TECHNICAL NOTE

PROJECT: Land west of Pagham Road – Approval of Reserved Matters (planning references: P/155/21/RES and P/158/21/RES)

REPORT: 2152/TN/03 – Response to highway officer consultation dated 30th November 2021

Figure 1 – Extract of updated access proposals

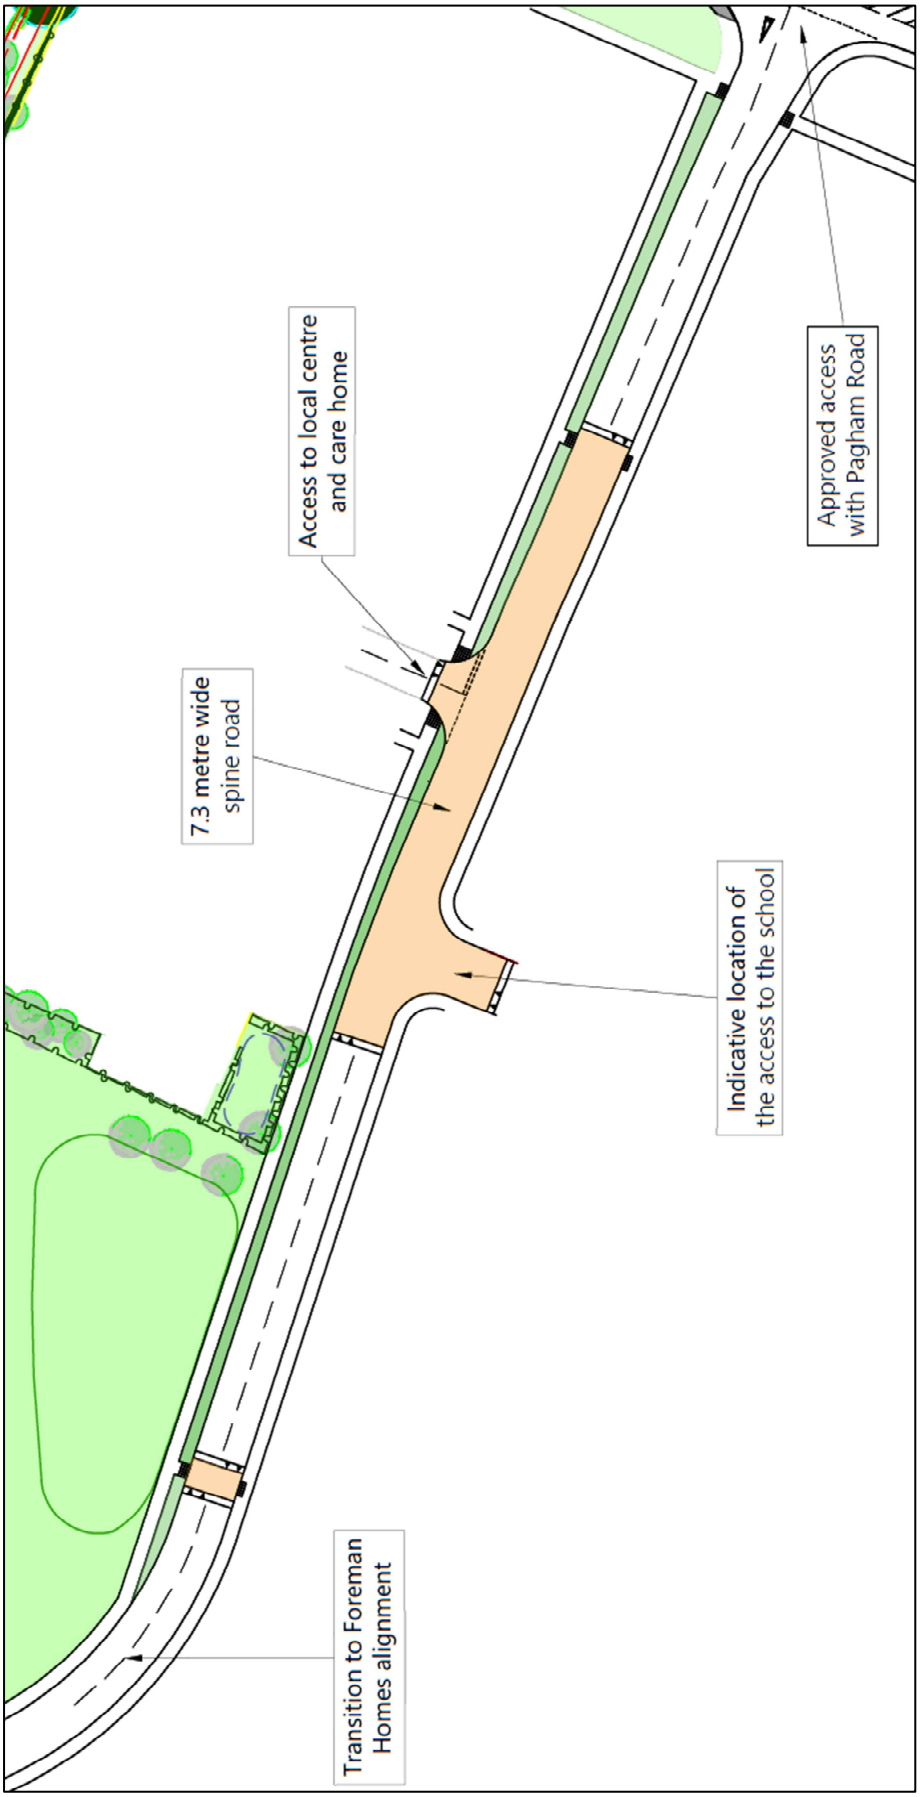
The proposed raised tables on this section of the spine road should be reviewed

It's also recommended that the single raised feature to the west of the raised feature incorporating the community uses and school accesses are combined to form a single feature across the school/community use frontages. The single short raised feature in isolation serves little purpose particularly given it's close proximity the longer raised table.

15. It is understood that the highway officer is referring to the raised crossing the to the east of the main raised table. The raised table to the west of the main table is intended to ensure speed are kept low between the local centre/school and the wider residential development to the west.

16. A plan of the updated access proposals (HTp/2152/07/D) combining the main and eastern raised tables is provided at **Appendix 3** with an extract at **Figure 1**.

i. A raised table that includes the junction with the local centre, school and a pedestrian crossing
    ii. Uncontrolled pedestrian crossing at the junction with Pagham Road
    iii. Raised uncontrolled pedestrian crossings of the Spine Road, including tactile paving to the west of the local centre access
    iv. Visibility splays of 2.4 x 25 metres which are conducive with the 20mph speed restriction along the spine road.

18. It is therefore concluded that the proposed raised table arrangement is appropriate and will be effective at reducing vehicle speeds.
